Errata

SLG46811

CE-GP-008

This document contains the known errata for SLG46811 and the recommended workarounds.

Figure 2: ACMP Output during Glitching

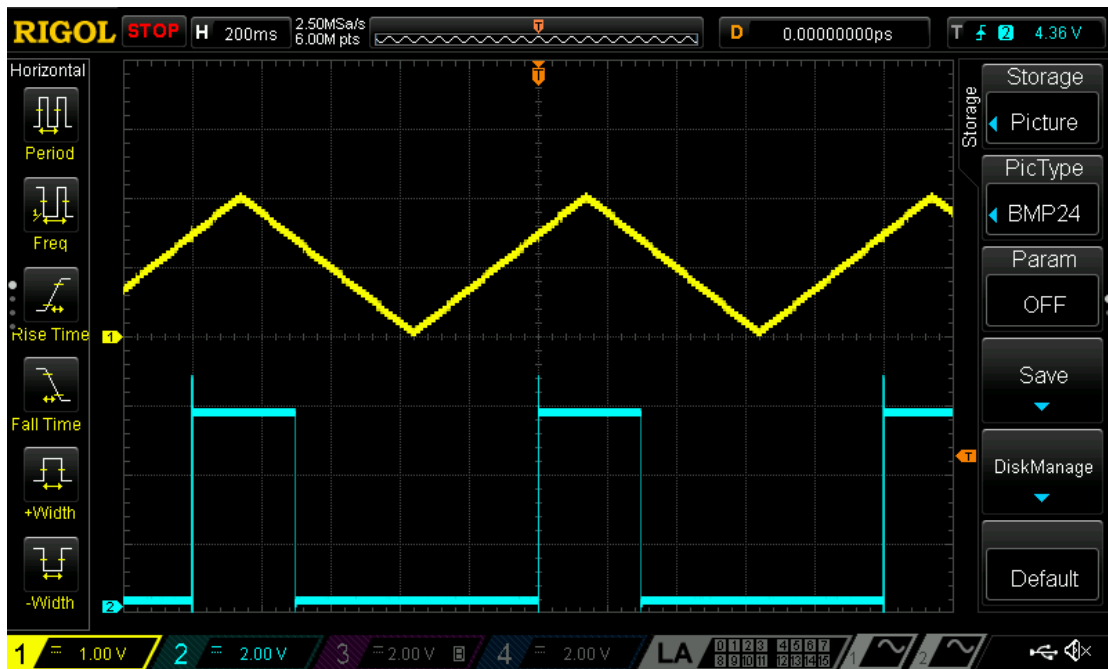
If using MS ACMP in Regular ACMP mode with 64 mV hysteresis, MS ACMP output could be glitching when MS ACMP positive input (IN+) close to the negative input (IN-). It can happen when $V_{DD} = 4.0$ V or higher and $V_{ref} = 1344$ mV or higher.

1. Waveform at $V_{ref} = 1536$ mV, hysteresis is equal to 64 mV.

1. Use the deglitch filter connected to the MS ACMP output.
2. Decrease the reference (below 1344 mV) at $IN-$ and add the $IN+$ gain to keep the needed threshold.
3. Use MS ACMP in multichannel mode.

Figure 3: Zoomed ACMP Output during Glitching

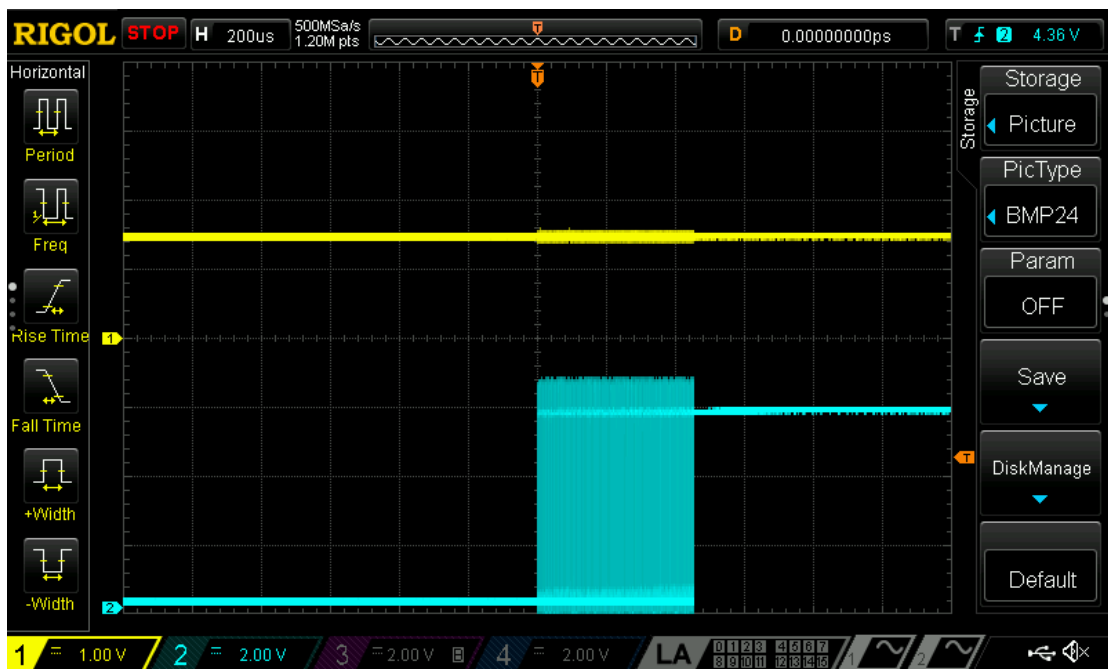
2. Waveform at $V_{ref} = 1536 \text{ mV}$, hysteresis is equal to 64 mV (zoomed rising edge).
